1		
2		
3		
4	Project	IEEE 802.16 Broadband Wireless Access Working Group <http://ieee802.org/16>
5		
6	Title	Figures pertaining to comments submitted in LB#6
7		
8	Date Submitted	2002-06-27
9		
10	Source(s)	Carl Eklund Voice: +358-7180 36566
11		Nokia Fax: +358-7180 36851
12		P.O. Box 407 mailto:carl eklund@nokia.com
13		Fin-00045 Nokia Group
14		
15	Re:	Working Group LB #6
16		
17	Abstract	Figures pertaining to LB comments
18		
19	Purpose	
20		
21	Notice	This document has been prepared to assist IEEE 802.16. It is offered as a basis for discussion and is not binding on the contributing individual(s) or organization(s). The material in this document is subject to change in form and content after further study. The contributor(s) reserve(s) the right to add, amend or withdraw material contained herein.
22		
23	Release	The contributor grants a free, irrevocable license to the IEEE to incorporate material contained in this contribution, and any modifications thereof, in the creation of an IEEE Standards publication; to copyright in the IEEE's name any IEEE Standards publication even though it may include portions of this contribution; and at the IEEE's sole discretion to permit other

Figure 1—Registration — SS

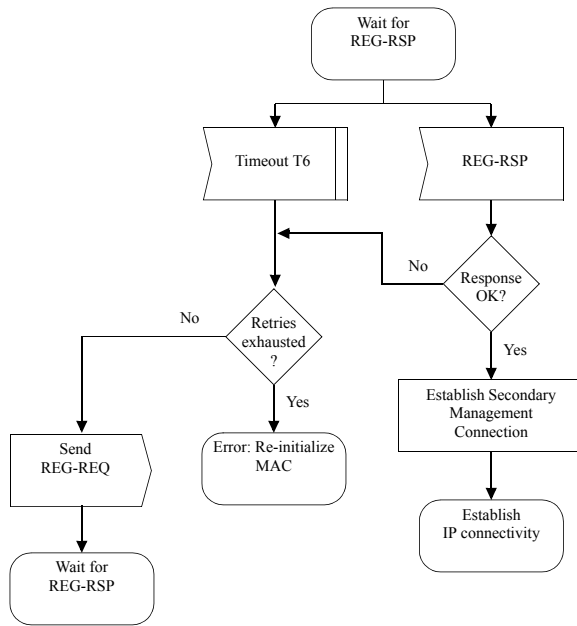
On page 112 replace figure 52 with Figure 1.

Figure 3—Registration — BS

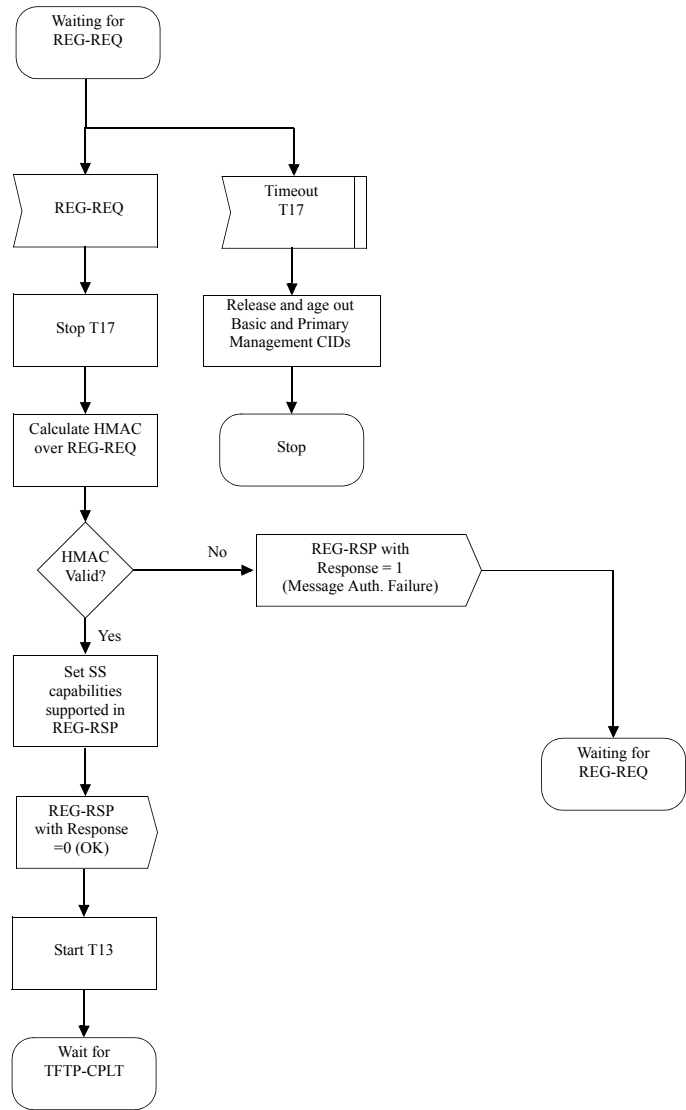
1 Replace figure 54 on page 113 with Figure 3 below. On page 113 in the second paragraph change “T9
 2 (defined in Table 118)” to “T17(defined in Table 118).
 3
 4
 5
 6
 7
 8
 9
 10
 11
 12
 13
 14
 15
 16
 17
 18
 19
 20
 21
 22
 23
 24
 25
 26
 27
 28
 29
 30
 31
 32
 33
 34
 35
 36
 37
 38
 39
 40
 41
 42
 43
 44
 45
 46
 47
 48
 49
 50
 51
 52
 53
 54
 55
 56
 57
 58
 59
 60
 61
 62
 63
 64
 65

Figure 5—Wait for SBC-RSP — SS

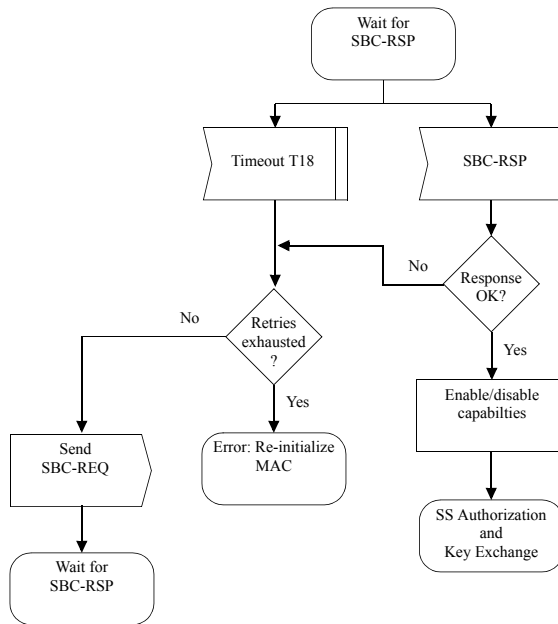
Add sentences to the end of paragraph 6.2.9.7 with the text “ The procedures that shall be followed by the SS are shown in Figure 4 and Figure 5. The BS shall follow the procedure shown in Figure 6.
